PL/26/0187

Condition 30 – SUDS

Sheet 1: BBLA watering notes and markups on condition 30 – SuDS (10/07/26)

Figure 1 *Tree Pits on Bedford Road Elevation*

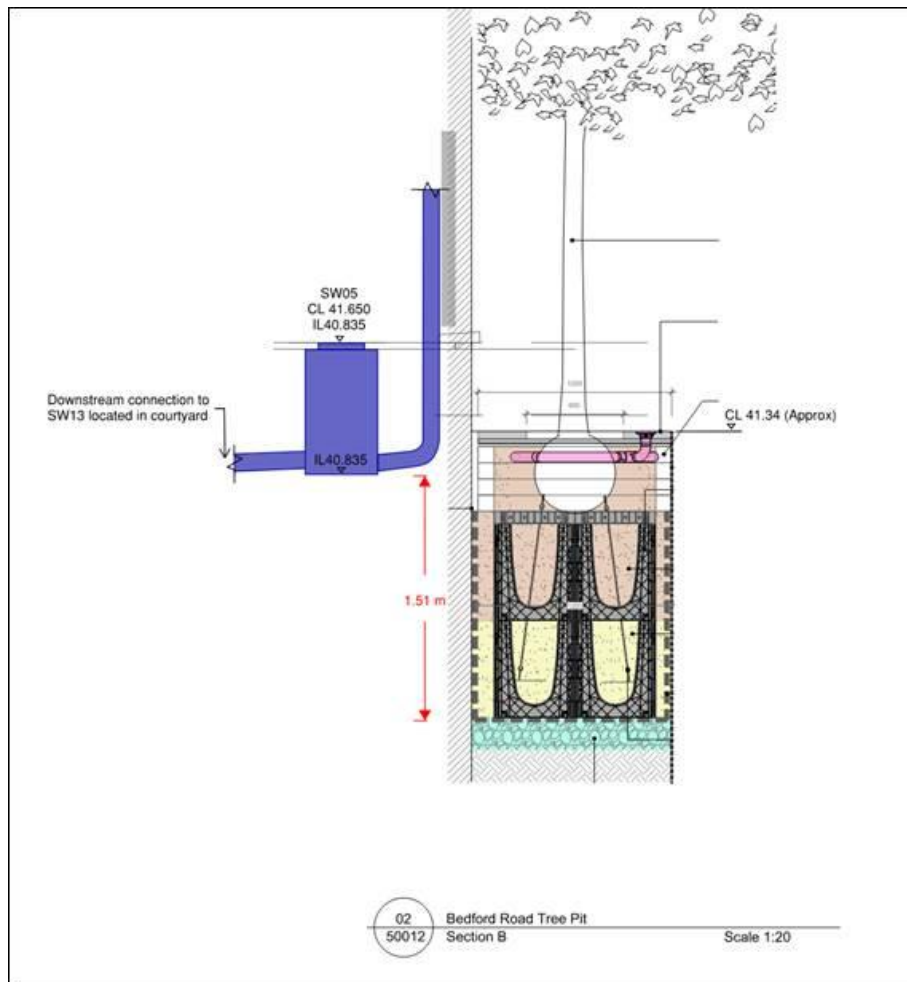
As shown on the typical tree planting detail provided by Boon Brown Architects, the tree pits comprise two RootSpace structural modules, resulting in the base of the modules being approximately 1.2 m below the root ball. Due to this depth, it is not possible to provide a piped connection back into the surface water drainage system. As shown, the

base of the modules would be approximately 1.5 m below the invert level of SW05, making a gravity connection unachievable (see Figure1).

Figure 2 Green hatch shows location of raised planters on the Battle Street Elevation

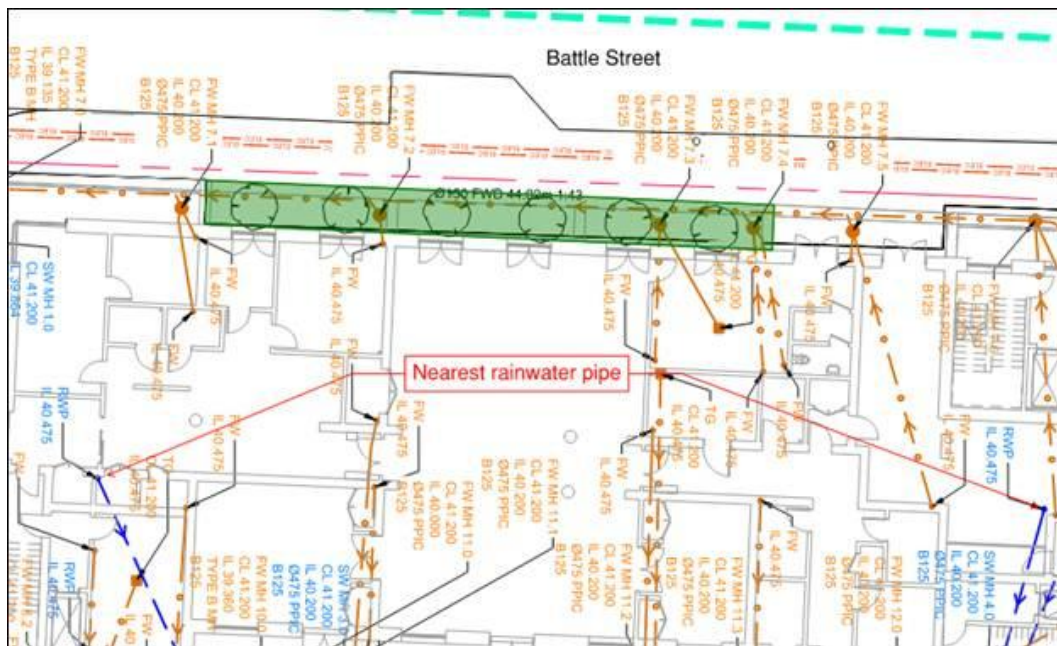
On the Battle Street elevation, roof water cannot be utilised for irrigation of the raised planters. No external rainwater downpipes are proposed on this frontage, consistent with design of the development granted planning permission. As a result, there is no external discharge point from which roof runoff could be directed into the planters, and therefore no feasible means of delivering a SuDS-integrated irrigation solution on this elevation (See Figures 2 and 3).
